Ducted Systems Technical Services Service Letter

Letter: **YS-004-2021**

Subject: **Residential control transformer defect – 208 Volt applications ONLY**

Product: YXV, AC21B, AL21B, YZV, HC20B, HL20B, AP, RFCX***P*2, AE, RFCX***E*2, AVC, AVV, ME, MVC, PCG, PHG, PCE, PHE (Single phase models only)

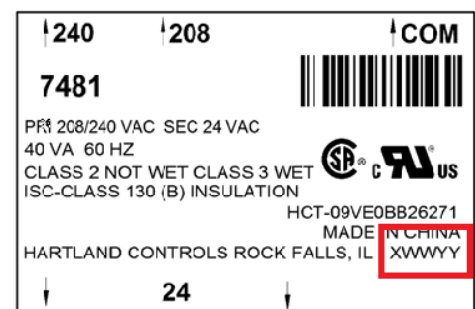
The above models utilize control voltage transformer 7481 which is service part S1-02518452700. Since 240 volt is the most common applied voltage, all equipment comes factory wired for 240 volt operation. Line voltage wiring is connected to the COM and 240 tap. There is a plastic cap on the 208 volt tap. Transformer 7481 is shown in the image to the right. The transformer label contains a date code.

The date code can be found in the lower right hand corner of the transformer label. See the image on the right showing date code as XWWYY. There are 4 date codes involved with this defect. Transformers with date code N3220, N3320, N4120, and N4320 are 100% defective **IF** the transformer is to be wired for 208 volt operation. Transformer failure is instant if equipment is properly wired for 208 volt operation and line voltage power is applied. Typically no damage will occur to any other electrical device, however, this defect is an inconvenience for an equipment installer or equipment start-up service technician.

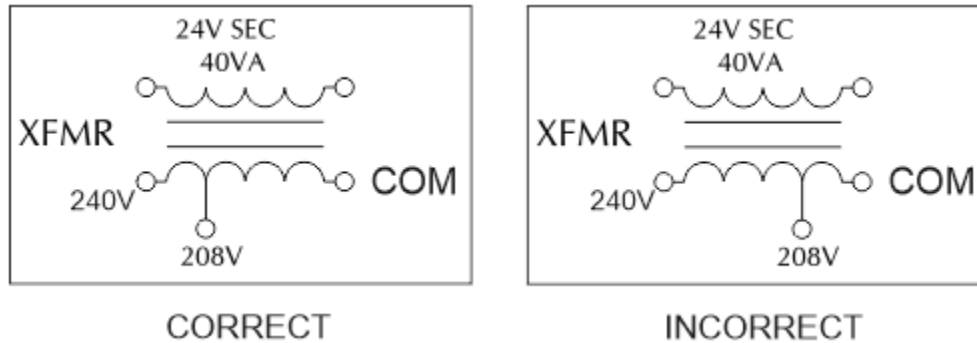
The images below provides a visual of the internal wiring of the control transformer. Notice the placement of the 240 and 208 voltage taps in relationship to the COM tap. The image on the left shows the 240 volt tap the furthest away from the COM tap and the 208 volt tap close to the 240 volt tap. The image on the right shows the 208 volt tap close to the COM tap. The image on the right shows the defect in which this service letter details. The connection of the 208 volt tap close to the COM tap results in low resistance across the taps and instant transformer failure will occur when wired for 208 volts and power is applied.

DATE CODE

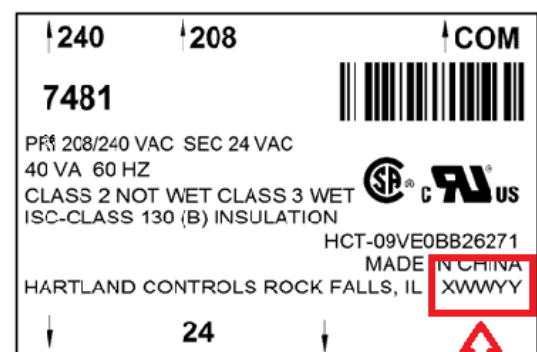
This piece of equipment *may* contain a control transformer with a defective 208 volt tap.

Prior to applying power to the equipment, inspect the label on the control transformer. The date code can be found in the lower right hand corner of the transformer label. See the image on the right. **If the date code reads N3220, N3320, N4120 or N4320, the 208 volt tap is located internally in the wrong location.**

To use an affected transformer on 208 volt power follow the following steps:

- Leave one LINE voltage power wire on 240 volt tap.
- Move the other LINE voltage power wire connected to the COM tap to the 208 volt tap.

The transformer will now function correctly for 208 volt applications.
